Subject: ACCESSORY ILLUMINATED DOOR SILL PLATE INSTALLATION INSTRUCTIONS CORRECTION	Service Alert No.: SA-027/22
	Last Issued : 05/10/2022

2023 CX-50

CLIP ORIENTATION

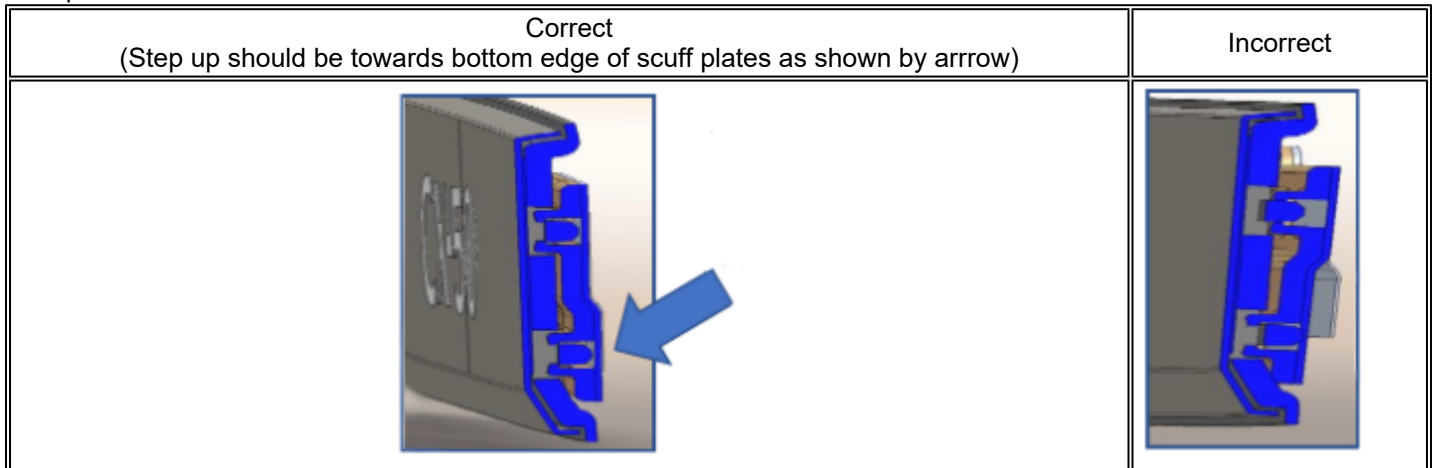
1. Remove both left and right front scuff plates from the foam sleeve.
2. Turn over and observe the orientation of the attachment clips located on the backside of the parts.

3. Clips should be oriented as shown below.

4. If clips are in the wrong orientation, remove them from the scuff plate and reinstall them in the correct orientation.

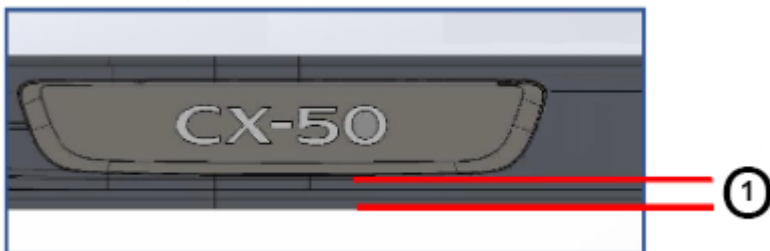
1. During Step 3 of the installation instructions, in addition to the items already mentioned, also remove the original side plastic trim.
2. Check that the scuff plate is parallel with the frame edge (1).
